Site Plan Comments: The site plan as submitted is not in general compliance with the Zoning Ordinance regulations.

01 SITE PLAN
SCALE: 1/32" = 1'-0"

GEMELLE
4400 WHITE SETTLEMENT ROAD
FORT WORTH, TEXAS 76114

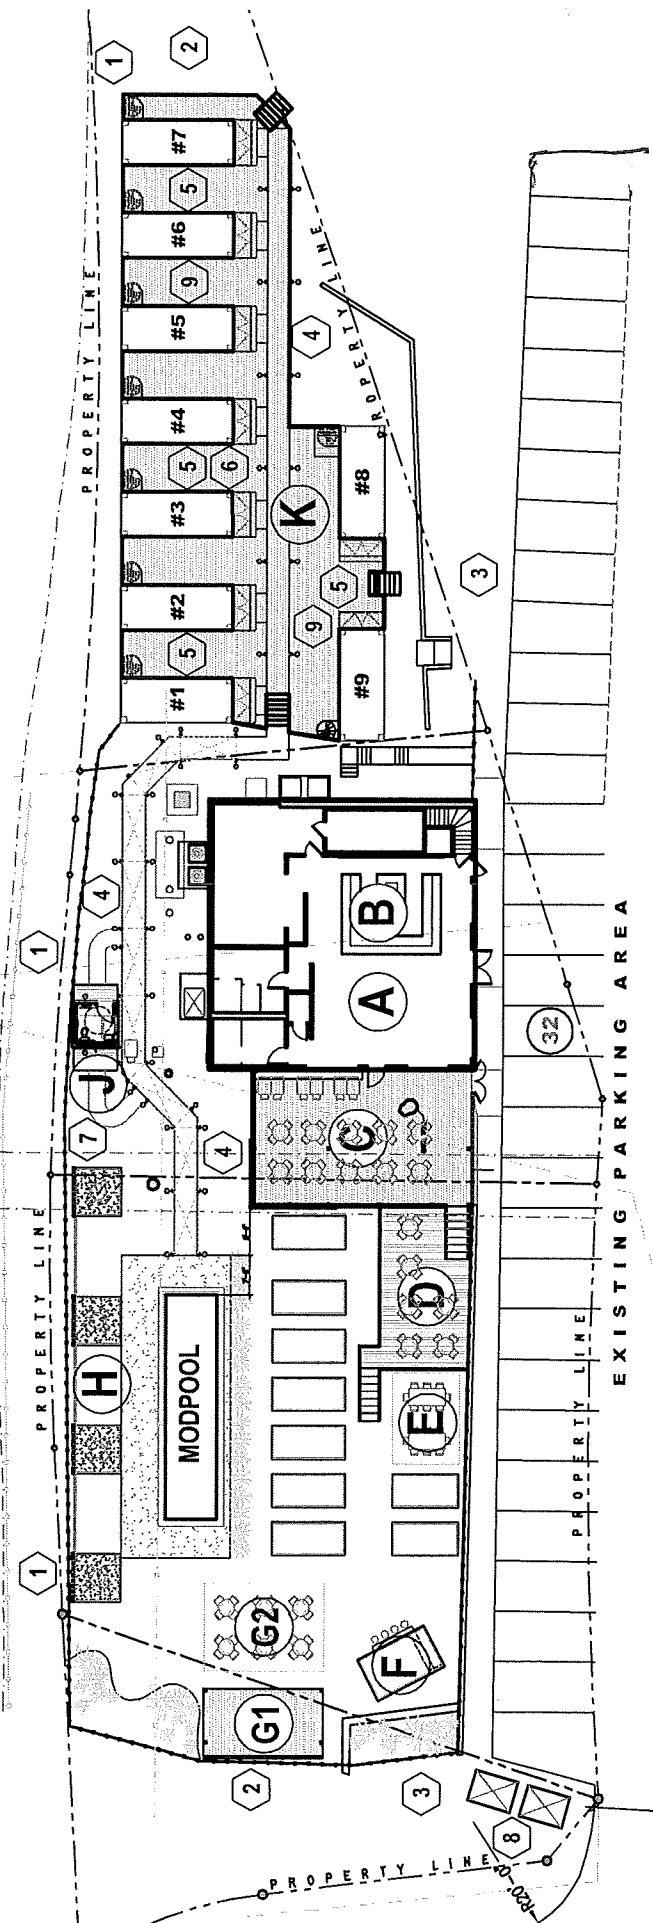
1. Parking for hotel is based on one space per bedroom, 1 space per 4 patron seats and 5 spaces per 1,000 sq. ft. display/ballroom area; nine cabins are proposed, 1 bedroom for each; 9 spaces required. The site is deficient by 27 parking spaces. **(recommended development regulation)**

2. Parking for restaurant is based on 1 space per 100 sq. ft. plus outdoor seating area; 50 spaces required. **(recommended development regulation)**
 - **(analysis: The restaurant use is allowed by right however, it is adjacent to a residential district boundary requiring a maximum parking count) Staff supports the request based on configuration of the lot.**

3. The site plan does not indicate parking on the south side according to aerials, is that to be included in this site plan?
4. Required rear yard supplemental setback is 20'; 5 - 18' provided. **(recommended development regulation)**

5. Required side yard supplemental setback is 20'; 10-18' provided. **(recommended development regulation)**
 - **(analysis: Based on the configuration of the property and the adjacent residential zoning district and having to adhere to the supplemental setback) Staff supports the request.**

6. Bufferyard requirements are 5'; 2'-5' provided. **(recommended development regulation)**
 - **(analysis: Based on the configuration of the property and the adjacent residential zoning district and having to adhere to the supplemental setback) Staff supports the request.**

- **(analysis: The use would be allowed by right through the PD, however, it is adjacent to a residential district boundary requiring a development regulation standard) Staff supports the request based on configuration of the lot.**

- **(analysis: Based on the configuration of the property and the adjacent residential zoning district and having to adhere to the supplemental setback) Staff supports the request.**
